STAFF REPORT: 02-12-2025 MEETING PREPARED BY: G. LANDSBERG

**APPLICATION NUMBER:** HDC2024-00694

**VIOLATION NUMBER:** 24-955 **ADDRESS:** 701-703 W. CANFIELD

**SCOPE:** ERECT ROOFED STAIR STRUCTURE AT REAR (REVISION TO PREVIOUSLY APPROVED DESIGN, WORK STARTED WITHOUT APPROVAL)

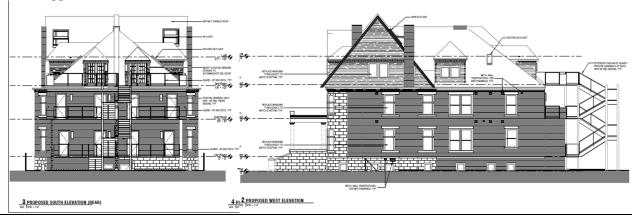
The applicant proposes a revision to the previously approved rehabilitation design (2020). Proposed is a reorientation of the multi-level stair tower along the rear of the building, and the crowning thereof with a hippedroof element intended to prevent water accumulation on the stairs in accordance with building code egress requirements. The structure is proposed to be built of wood and is designed to exist independently from the historic roof, but integrate with it by reproducing its pitch.

- Staff assesses that, despite its increased visual impact on the rear of the building, the roofed stair is a reasonable addition to the building under the Secretary of the Interior's Standards, that is necessary to satisfy a technical concern in the context of a larger rehabilitation (i.e., cumulative effect), that includes a high quality exterior (and interior) rehabilitation of the building and returns the building to a productive reuse after decades of disuse.

Design approved by the Commission, and signed-off by staff for construction, in 2020. Note configuration/size of rear stair.

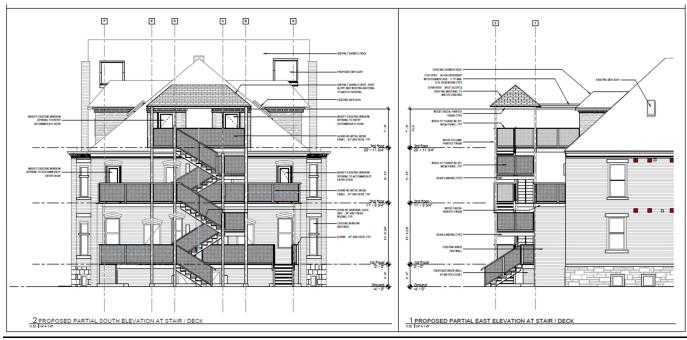
• The rehabilitation of this building, as originally approved by the Commission in 2020, is in support of an adaptive reuse of all levels, including the 3<sup>rd</sup> floor attic, for residential, multi-family use. This change of use from two-family to multi-family triggered a requirement that all work meet current building code requirements, including the addition of an egress path from the attic level to grade at the rear of the building. This required egress path was originally intended to be accommodated *within* the building, out of the jurisdiction of this Commission. At the same time, an exterior stair was proposed and approved as part of the rehabilitation, but was *not* the code-required egress stair at the time of the Commission's approval.
